Village Board Meeting
Agenda
Tuesday, October 25, 2022
5:30 p.m.

TO: **Intergovernmental Agreement (IGA) Joint Commission & Village of Somers Plan Commission**
FROM: **Luke Godshall, Senior Land Use Planner**
RPT DATE: **09-27-22**
MTG DATE: **10-10-22**
RE: **Somers Bobcat**

SOMERS BOBCAT RETAIL DEALERSHIP

SITE DIMENSIONAL & PAVING PLAN

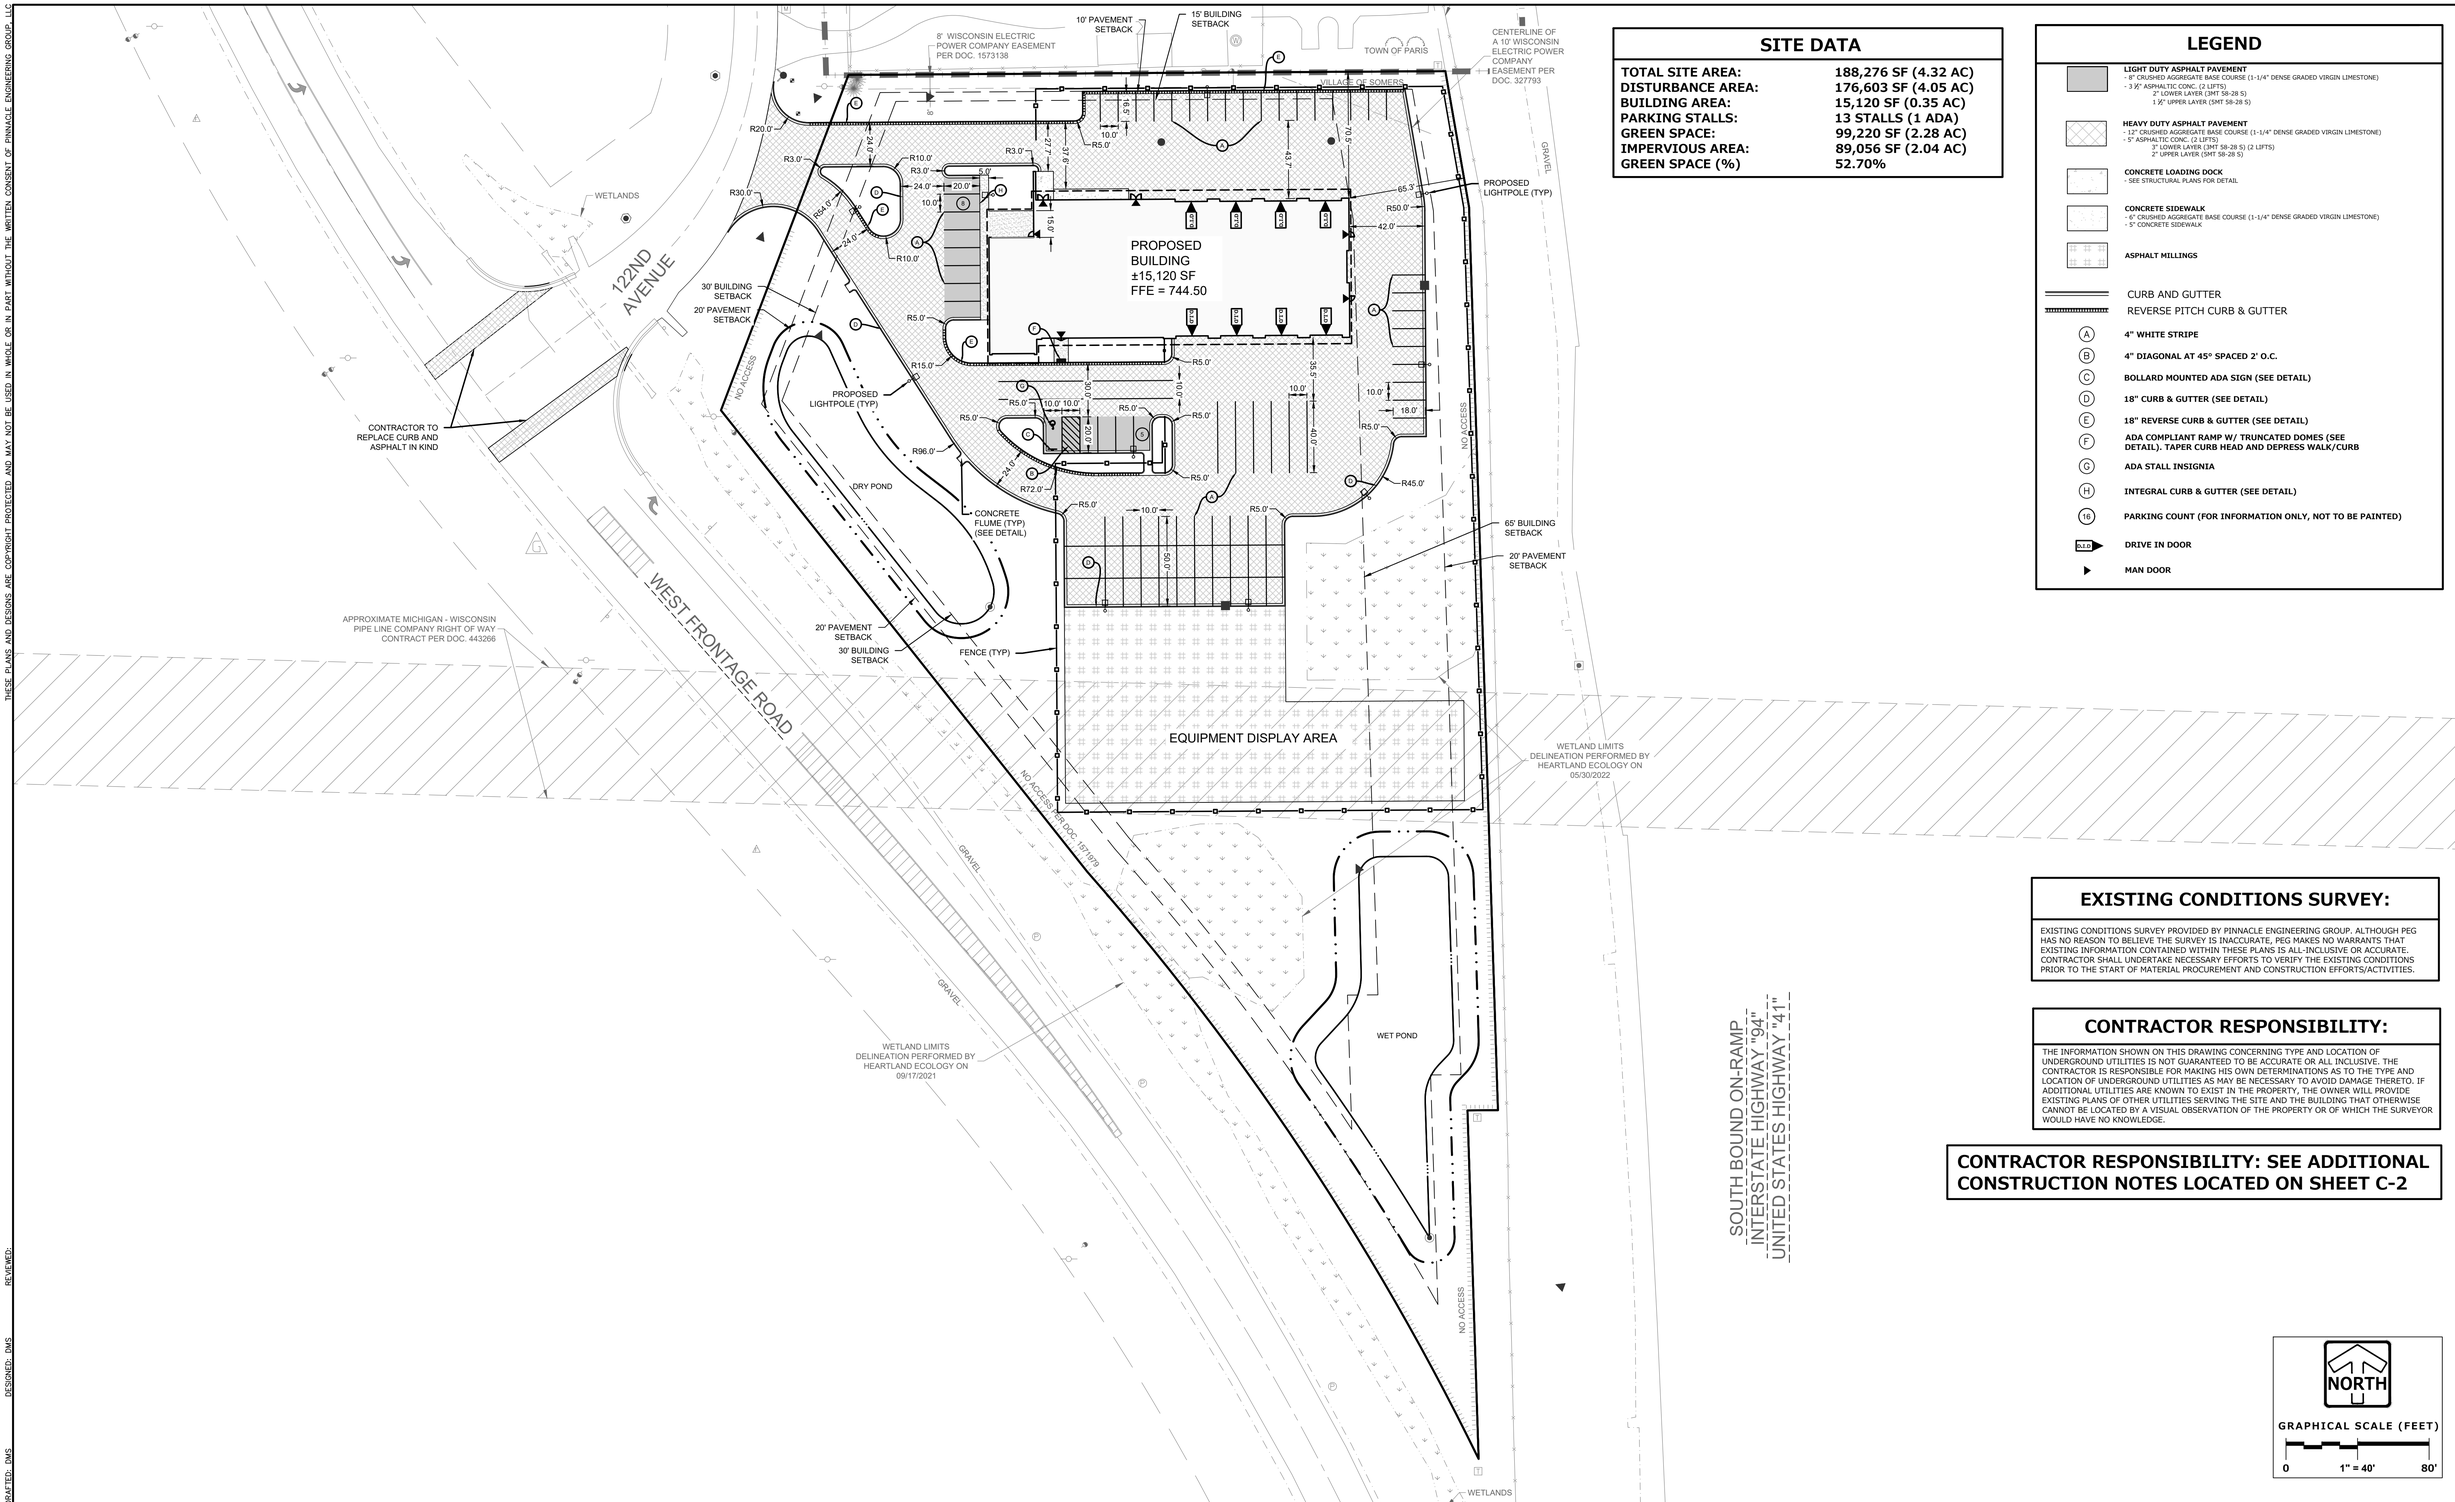
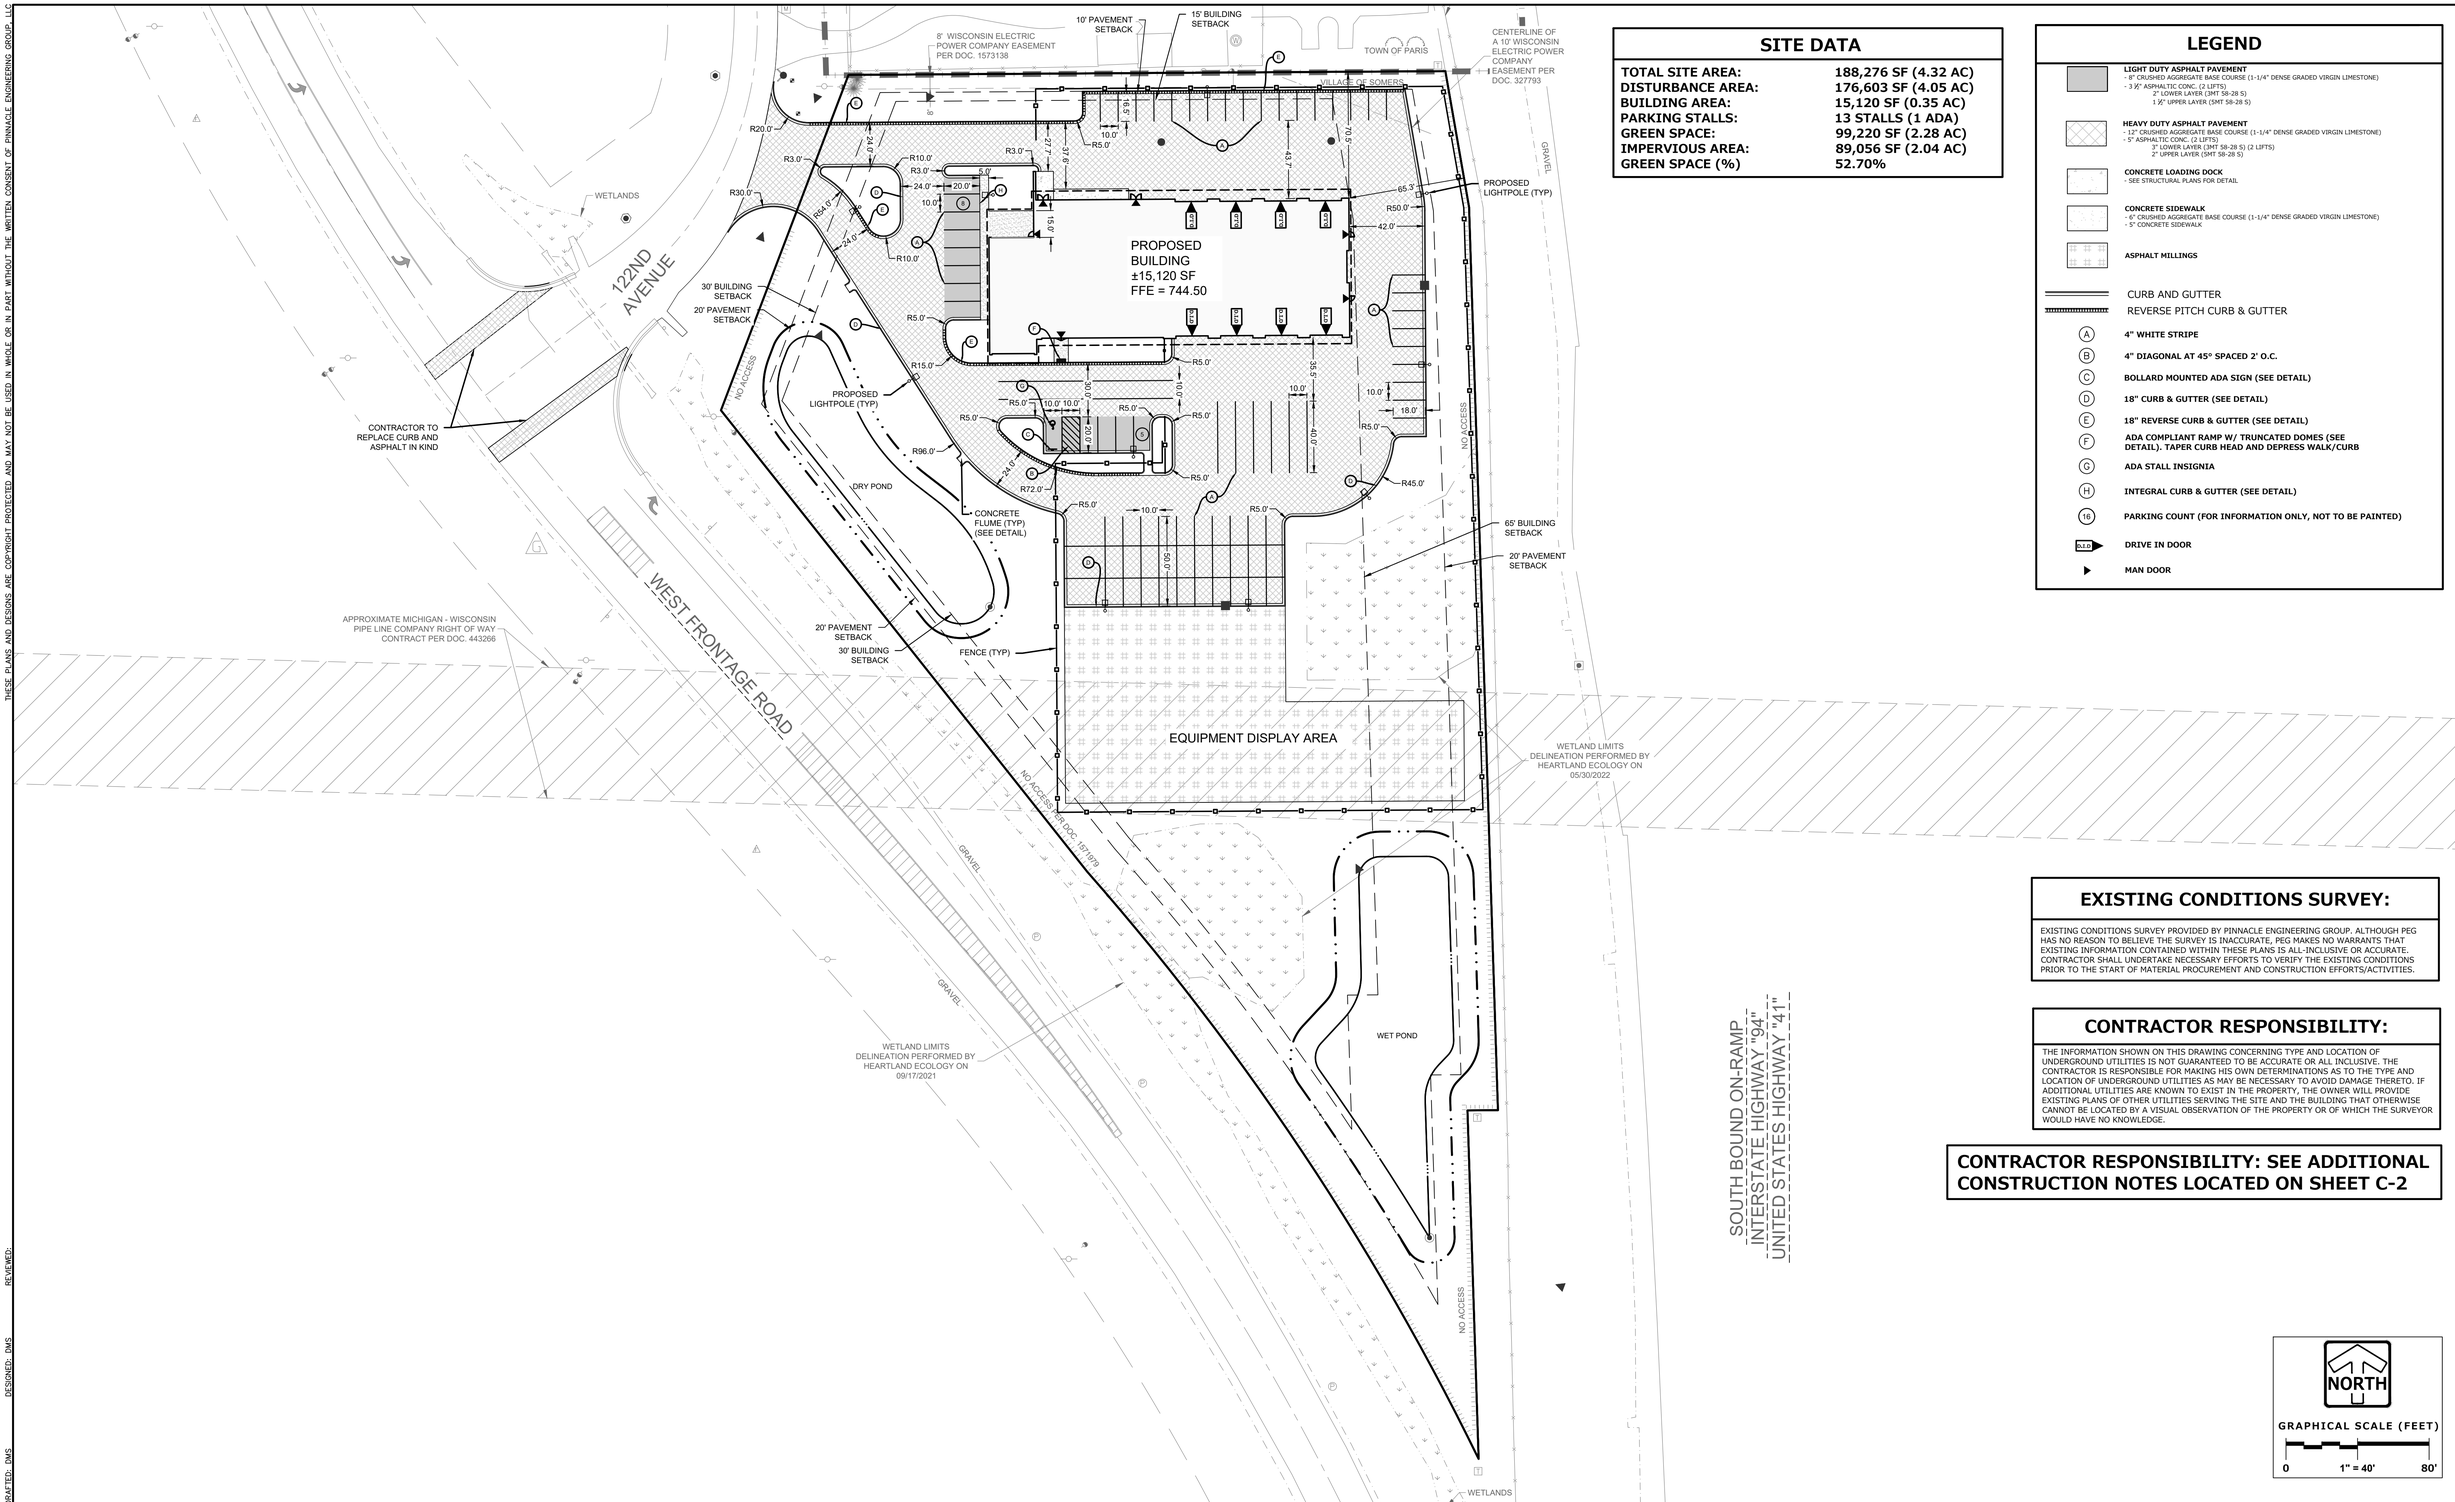
The site plan indicates that a fence will surround the equipment display area and outside vehicle/equipment storage areas on the north, east and south sides of the building. However, no details are provided on the submitted plans regarding the height or composition of the fence. The site design standards contained in the I-94 Corridor Neighborhood Plan indicate that outdoor storage areas shall be screened from view of any public street right-of-way, public park or public open space area, and from the view from all residential areas. Solid walls or fences shall be a minimum of 8 feet in height. Details of the proposed fence enclosing the outside storage areas will need to be provided.

The submitted plans do not show where, if any, outdoor trash dumpsters or garbage receptacles will be located. It is required that any outdoor trash dumpsters and garbage receptacles be screened by an enclosure consisting of masonry materials and coniferous landscaping materials of an adequate height (at the time of installation) to totally screen the trash storage areas from view from public rights-of-way and adjacent property. The enclosure shall not be less than 6 feet in height nor exceed 8 feet in height. Details of any proposed trash enclosures will need to be provided.

PARKING:
The submitted site plan shows a total of 13 customer parking stalls being provided. Under the Somers zoning ordinance, the number of off-street parking stalls required for "Automobile sales or rental, farm equipment sales or service" uses are 1 space for every 100 sf, plus 1 space per 500 sf of outdoor display area. The Petitioner is proposing a building of 13,325 sf (133 spaces), and an outdoor display area of approximately 19,000 sf (38 spaces) – for a total of 171 spaces required by ordinance. It is recognized that applying this standard to the subject site would not be feasible. Therefore, it is suggested that the IGA Joint Commission & Village of Somers Plan Commission allow the Petitioner to submit evidence and documentation as provided for under Section ZN 3.06(3)(d) of the Somers zoning ordinance to show that adequate parking and unloading areas will be provided for customers, clients, visitors, and employees and that the proposed operation requires less parking than the ordinance requires. In light of concerns brought up by the IGA Joint Commission at the conceptual hearing in August, it is reiterated that all customer parking, loading, unloading and/or parking of trailers must be provided on-site and in no case shall any parking, loading, unloading and/or parking of trailers occur within any road rights-of-way.

Because the proposed use borders a neighboring residential use to the north, the Somers zoning ordinance requires a parking surface setback of 20'. The Petitioner is requesting relief from this standard to allow a 10' parking surface setback from the north lot line though a PUD Planned Unit Development Overlay request.

GAS PIPELINE EASEMENT:
There is a gas pipeline easement running through roughly the middle of the property in an east-west direction. The submitted site plans show a major portion of the proposed equipment display area and fencing located within the easement area. At this time, it is unknown if the pipeline will allow these improvements to be located within the pipeline easement. The Petitioner has indicated to staff they are in communication with the pipeline and have so far received only a verbal approval pending further review by the pipeline. If approval by the pipeline is granted, it is recommended that written

documentation be provided. If the pipeline does not grant approval, the site plan will need to be revised to remove/relocate the improvements from the pipeline area.

6. The Petitioner shall provide details regarding the proposed outside storage area fence enclosure, particularly fence height and type (material) of fence to be installed.

7. The Petitioner shall provide details regarding any proposed outdoor trash enclosures, as well as including the location of any such trash enclosures on the site plan.

J1 EXTERIOR ELEVATIONS - NORTH FACADE

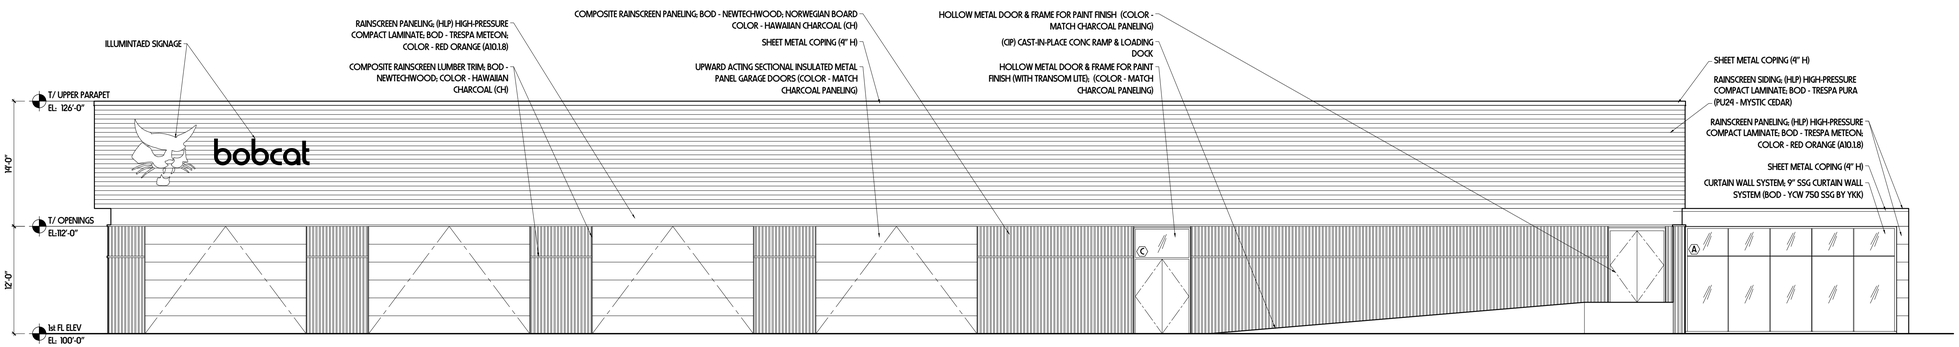
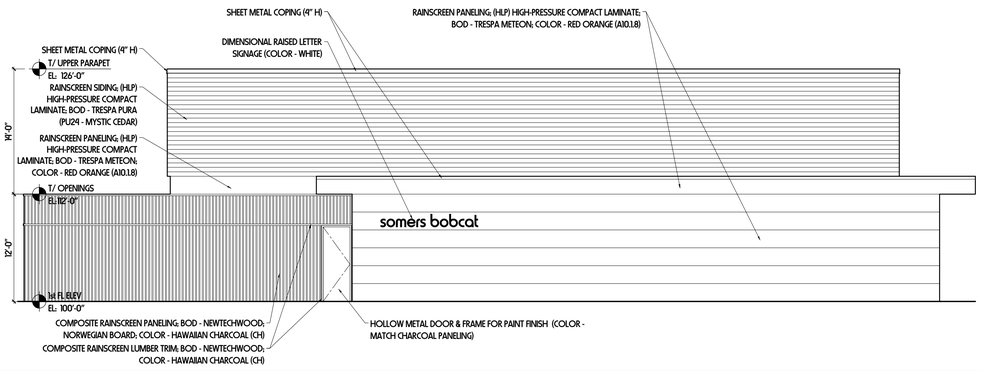
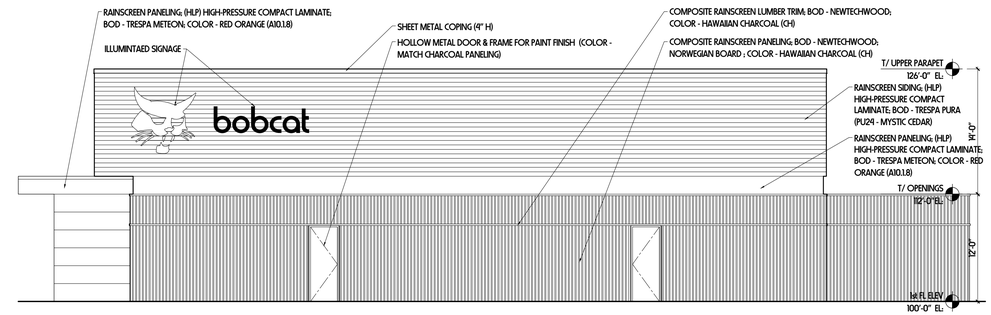
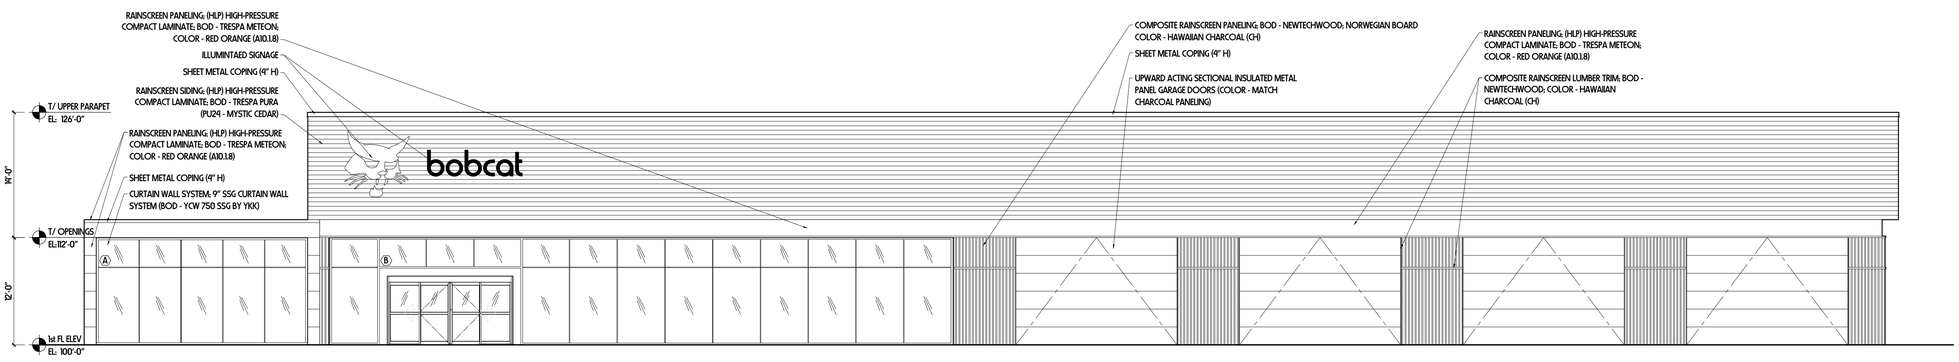
The exterior building elevations indicate the building would be composed of a variety of materials on all four elevations. Although the elevations do indicate the names of colors to be used, color elevations and color perspective drawings were not included with the updated plan set. The submitted building plans also do not indicate the location of auxiliary building equipment such as heating, ventilating, and/or air-conditioning equipment, which are required to be screened appropriately. It is recommended that updated or additional plans be submitted to show these details.

Commissioner Stoner- Specific questions regarding materials used to construct the building. He reiterated that no approval would occur for an aluminum or steel structure. Bobcat ensured Mr. Stoner of the quality of materials used. Wood fiber cedar wrapping will encompass the building. Mr. Stoner reiterated the complete rendering data be provided to the board.

5. The Petitioner shall submit color building elevations and perspective drawings, as well as plans that indicate the location of any auxiliary building equipment such as heating, ventilating, and/or air-conditioning equipment and how this equipment will be screened.
